GeoShield Verification Report

PROJECT REFERENCE: GEO103300

PROJECT: Leeds Road, Mirfield

AREA SURVEYED: Plots 7 & 8.

VERIFICATION ITEM TWO

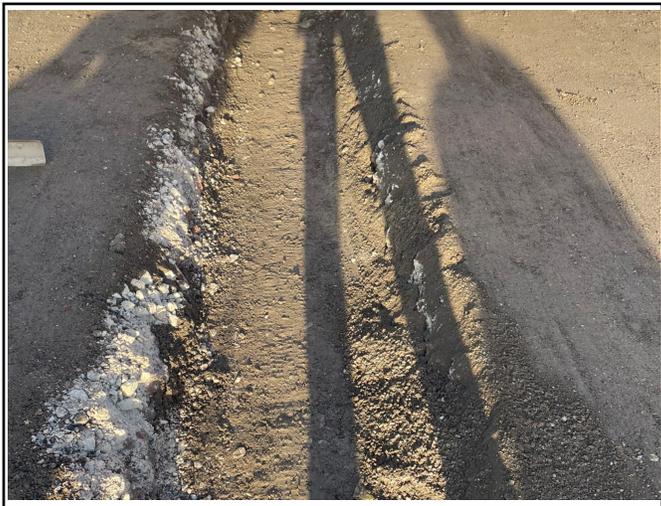
The two images show the extent of the internal thickenings where like the perimeter thickenings, un-prepared. The main issues was the amount of stone lining the battered sides of the thickening trench and further sand blinding would be required to line these

areas before any of the Rhinoplast TGB could be completed. The issues surrounding the amount of preparation works still required would mean the Rhinoplast TGB could not possibly have been installed by close on 21/12/2022 including verification. This prompted a discussion as to an alternative solution because the concrete pour was planned for 22/12/2022 and time was against the proposed inexperienced installers.
